**CLINCH RIVER
BREEDER REACTOR PROJECT**

**PRELIMINARY
SAFETY ANALYSIS
REPORT**

VOLUME 20

FIGURE Q130.21-1 CELL LINER SYSTEM

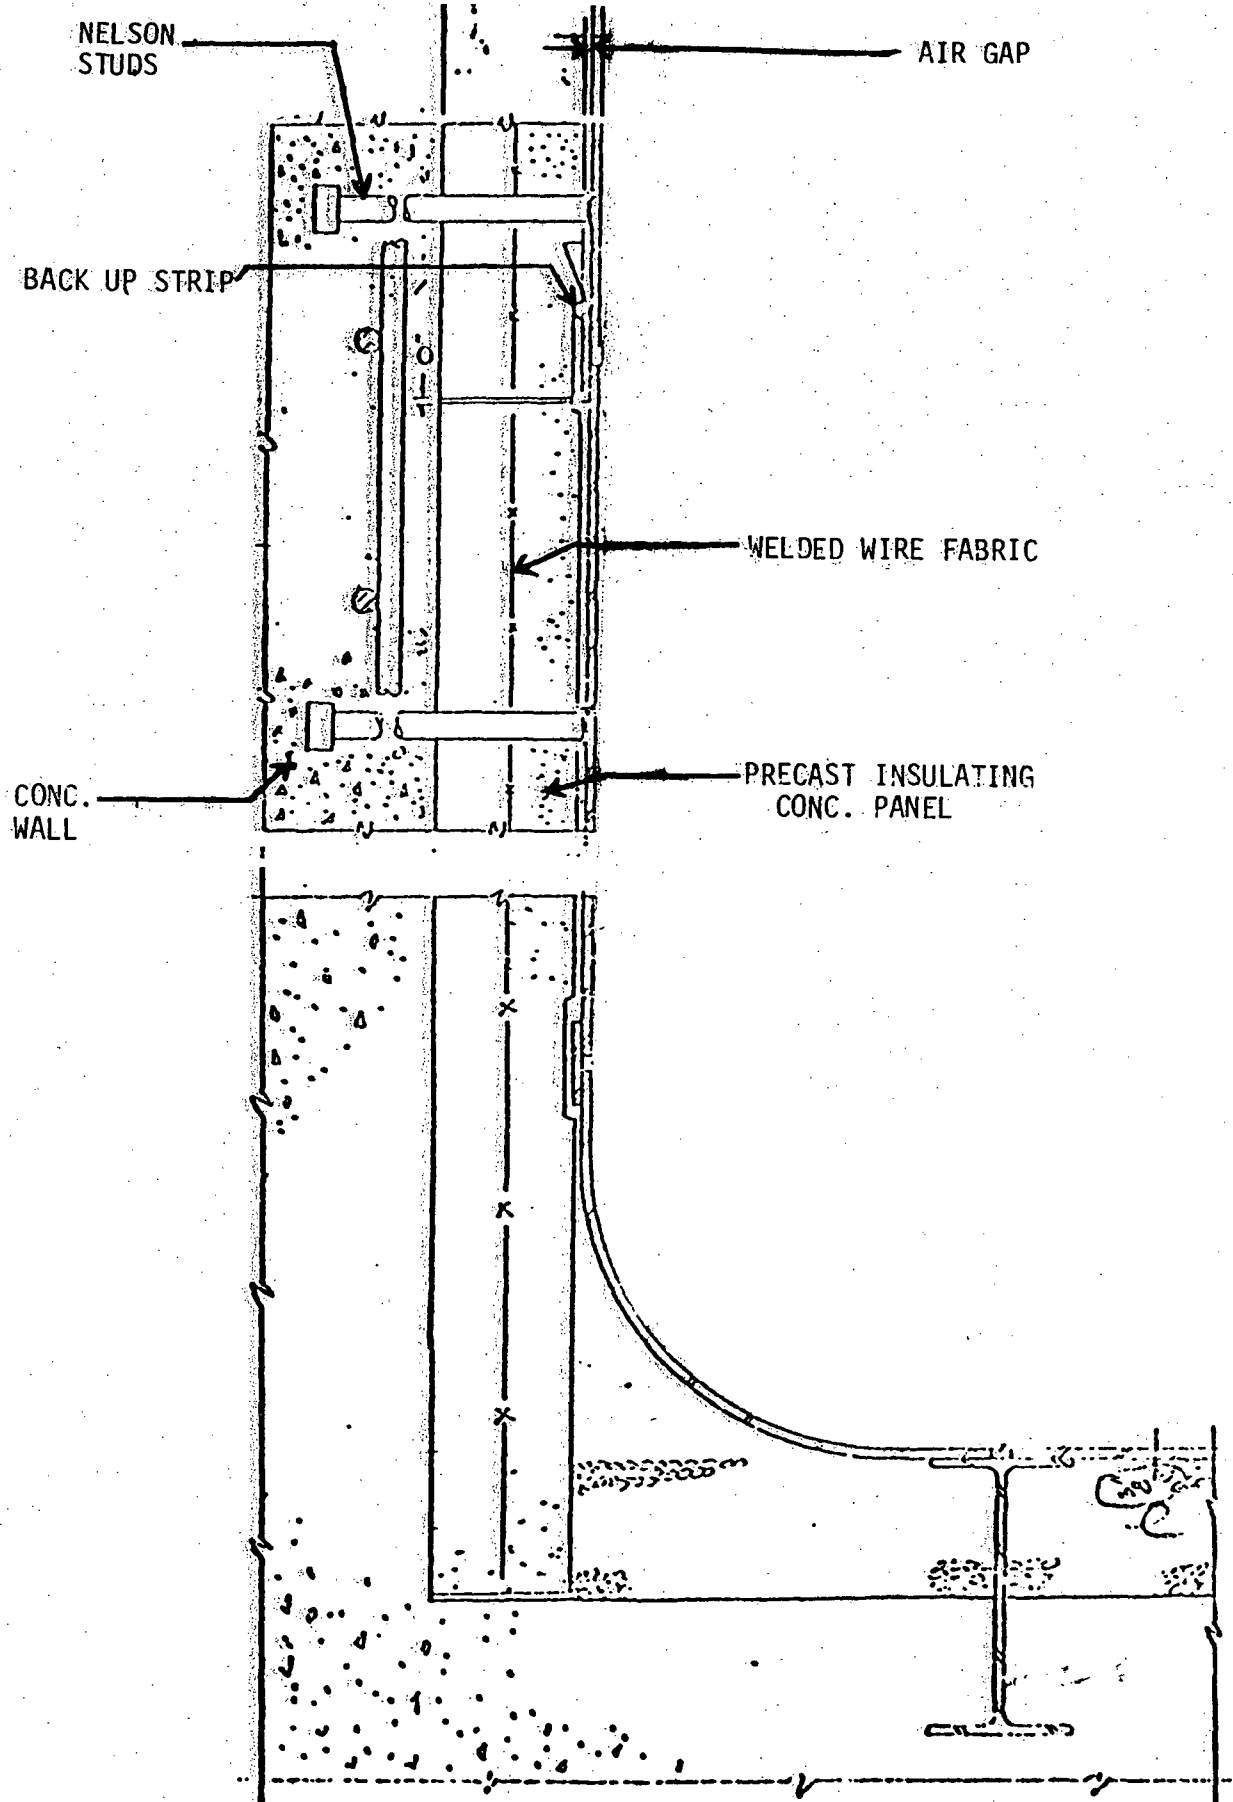
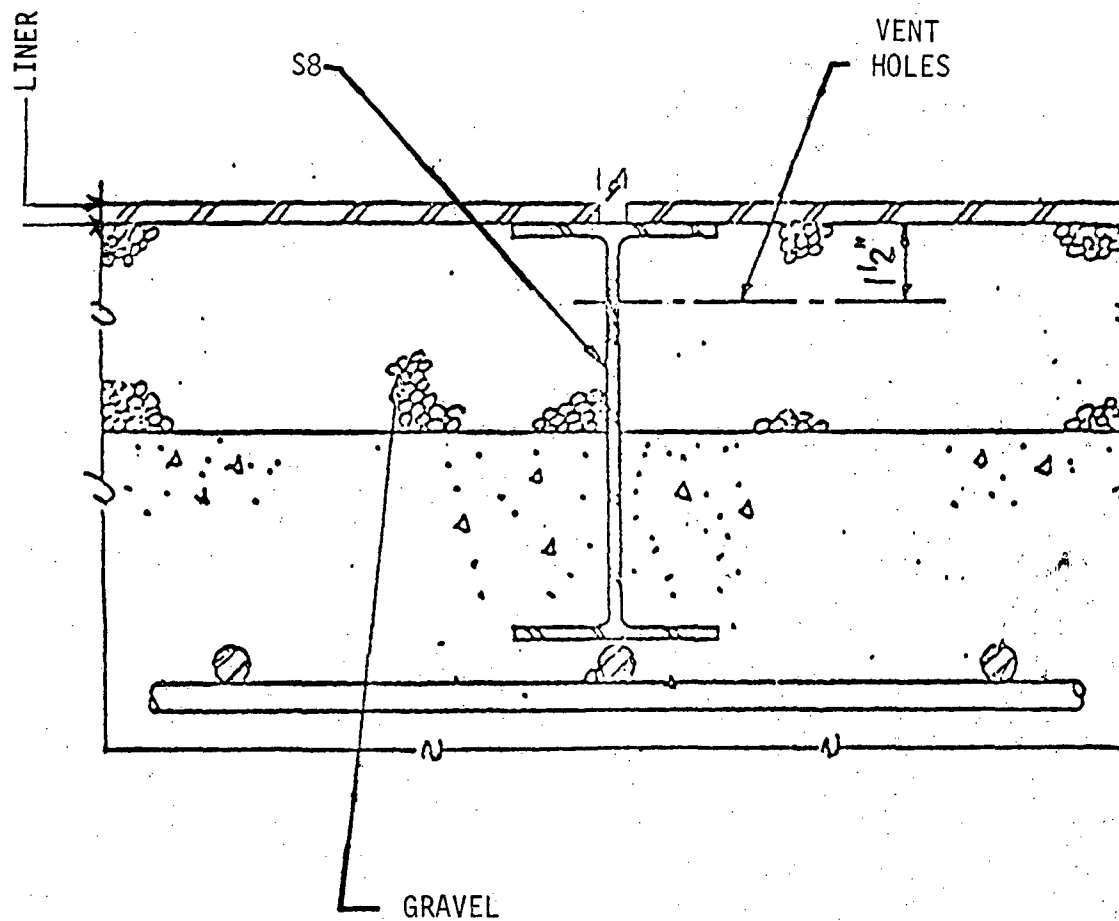
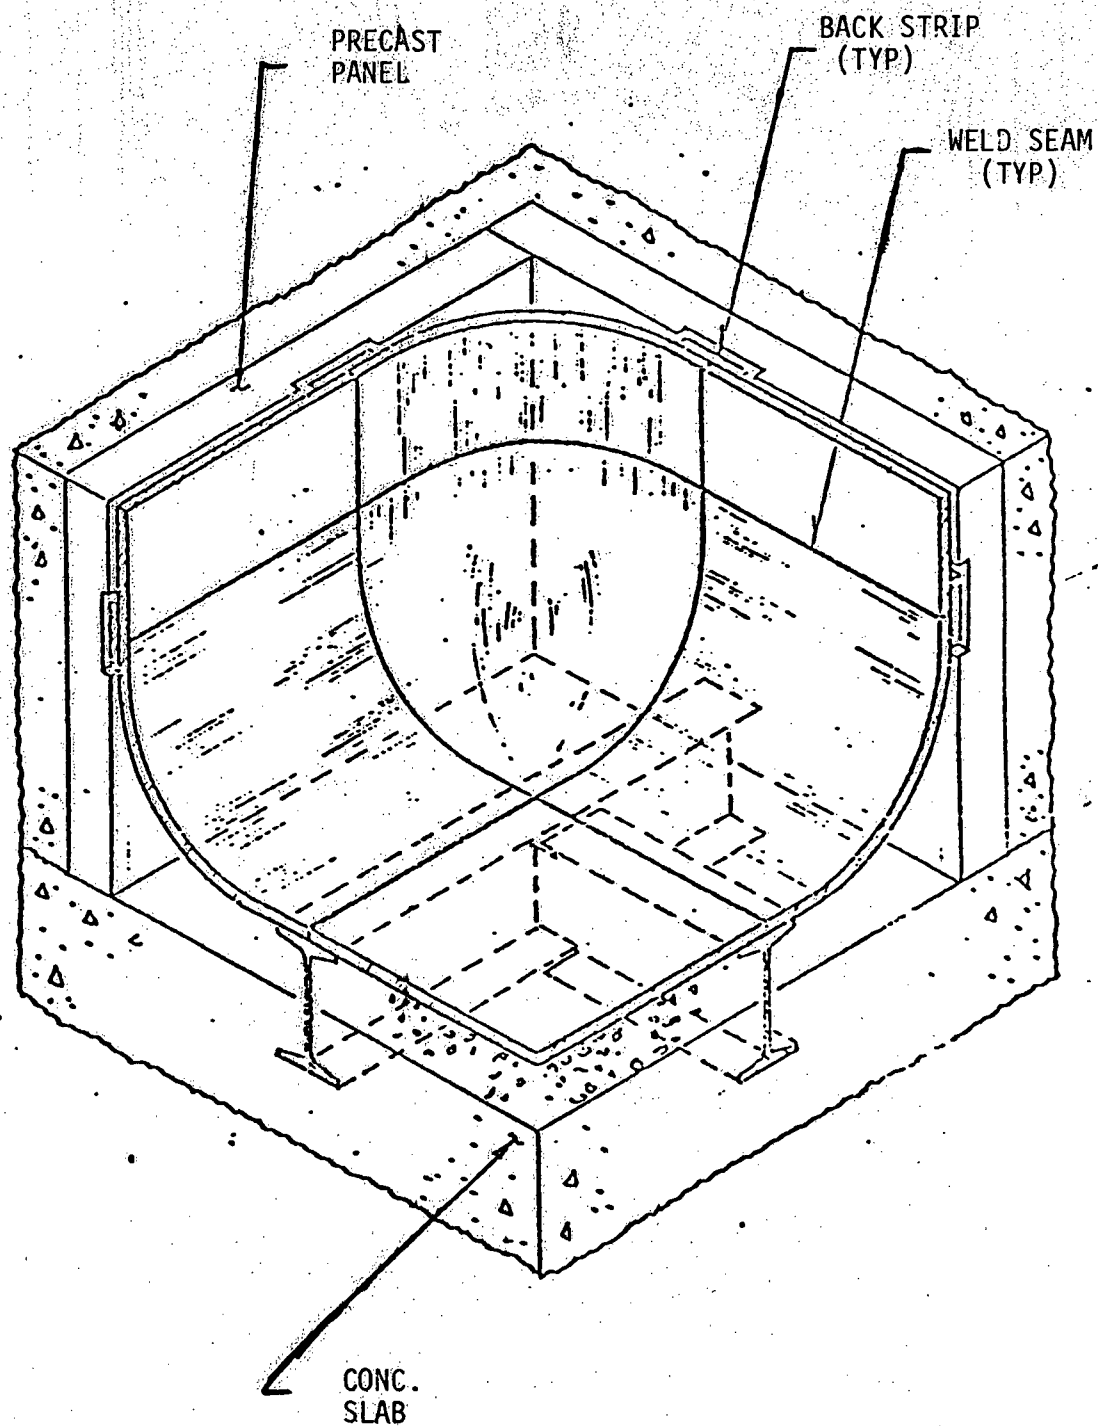
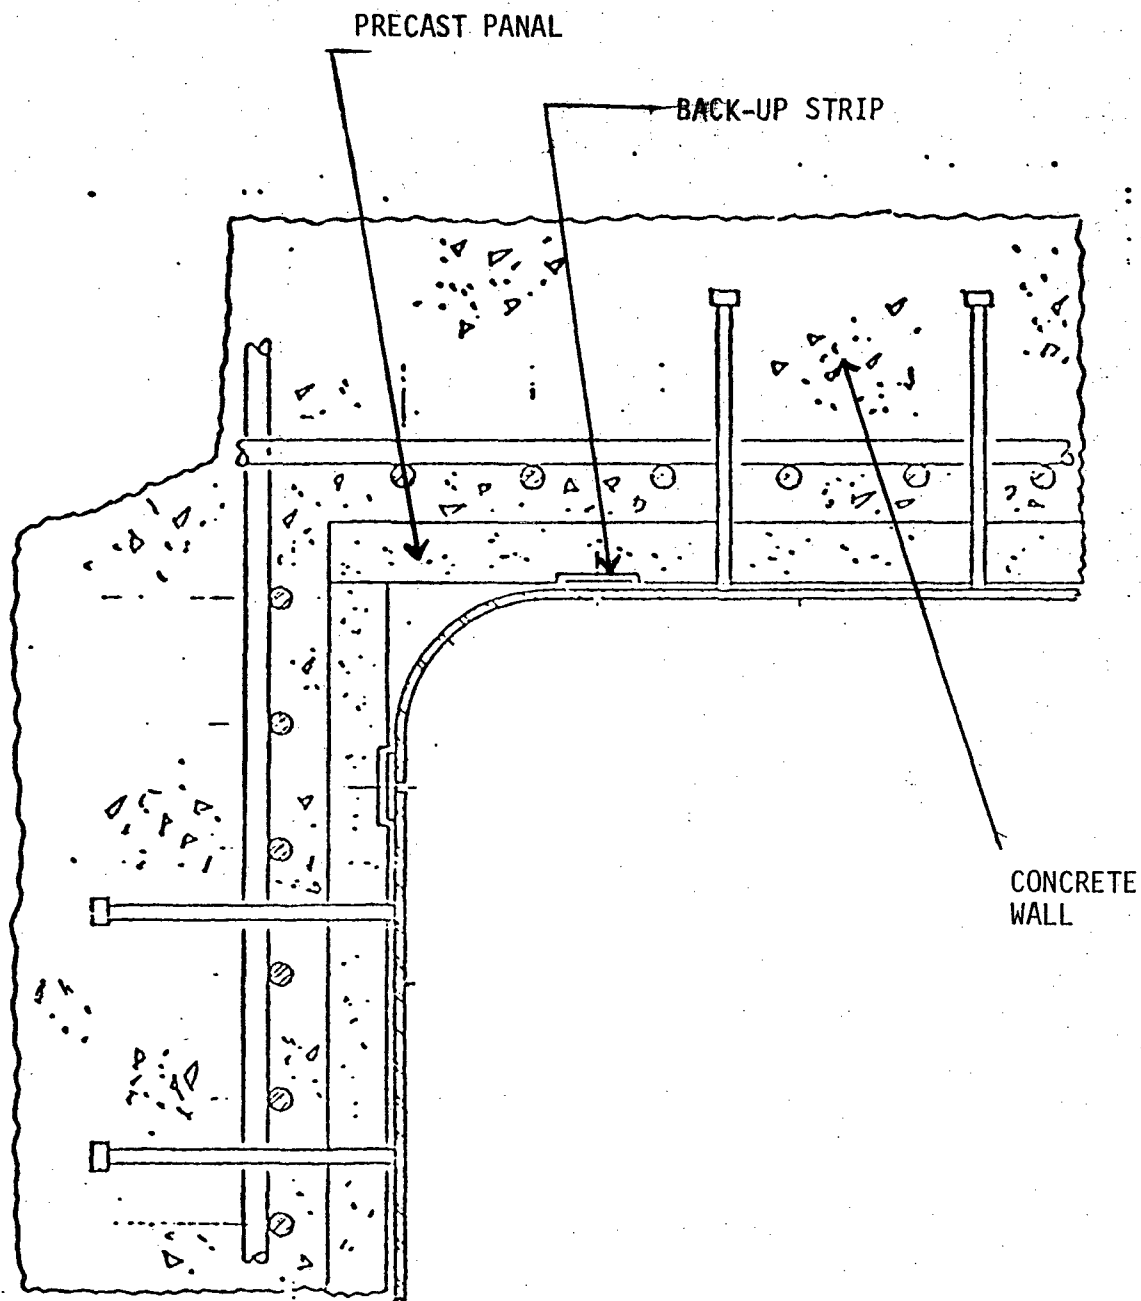
In 3.8.3.1, provide a detailed description with appropriate diagrams of the reactor cavity cell liner and other cell liners. Furthermore, provide a discussion of the design and design criteria of the following: sacrificial layers in the steel liner and backup concrete; strength and stiffness considerations for the sacrificial layers; stiffness reduction due to possible sodium corrosion; protection of dampers and snubbers from sodium spills; design variations for the cell liners of the primary sodium loops, compared with the cell liners of the secondary sodium loops; thermal buckling of the cell liner, thermal shears in the concrete; post thermal cracking dynamic resistance; and, liner anchorage in sacrificial or thermal cracked concrete.

For the extreme accident condition of the sodium spill, preliminary analyses indicate that the effective Von Mises strain will be below 6% which is less than the specified limit of 75% of the ultimate strain of the material, approximately 22%. This maximum strain level is based on analysis performed to date of liner panels and bi-planar corners. Analysis of a tri-planar corner is presently in progress.

Figure Q130.43-1. Reprint from Reference Q130.43-1

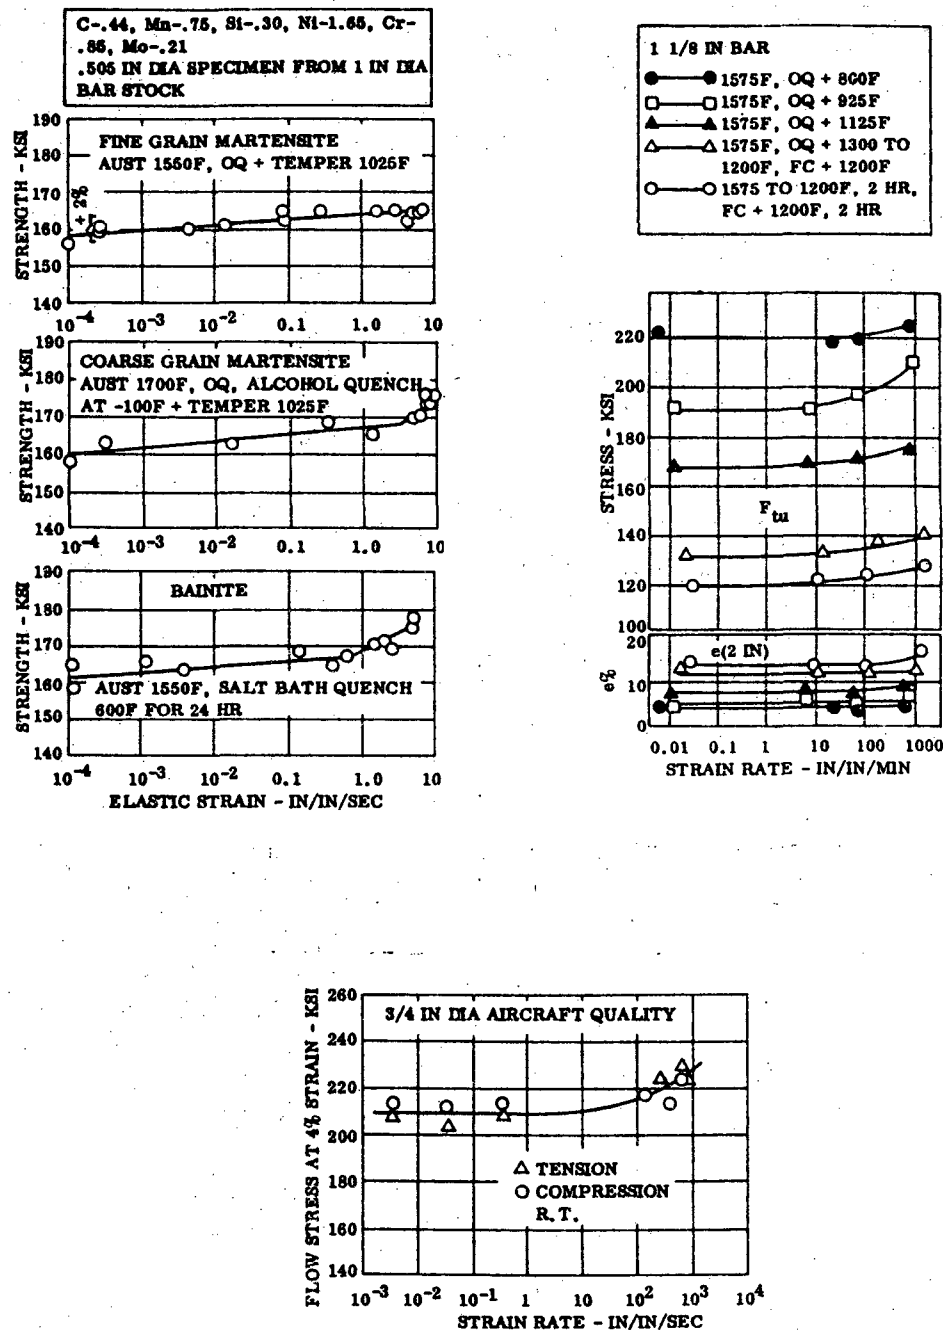
In Table F7.2-2, EVALUATION OF THE INNER AND OUTER REACTOR VESSEL SUPPORT BOLTS, there is a footnote which states: "Key Assumption: 1. Thread shear area is adequate to develop tensile strength." In Section 15.1.1.3.4.1 of the reference design there is the following statement: "Where analysis has indicated threaded fasteners inadequate, as in the case of the plug/riser assemblies, a structural restraint is accomplished by a load resisting shear ring." These statements infer that there may be some question regarding the adequacy of threaded fasteners to resist the CDA loads. If other types of fasteners are employed indicate their locations and provide a description of their attachment. With CDA load rise times on the order of several milliseconds and response rise times in tens of milliseconds indicate the bases for concluding that threaded fasteners can adequately resist such loads. Consider the effects of high strain rates upon material toughness, mobilization of ductility (particularly in shear), notch sensitivity and material defects. Provide a description of experimental programs, if any, to assess the adequacy of such fasteners at load magnitudes and strain rates equivalent to the CDA.
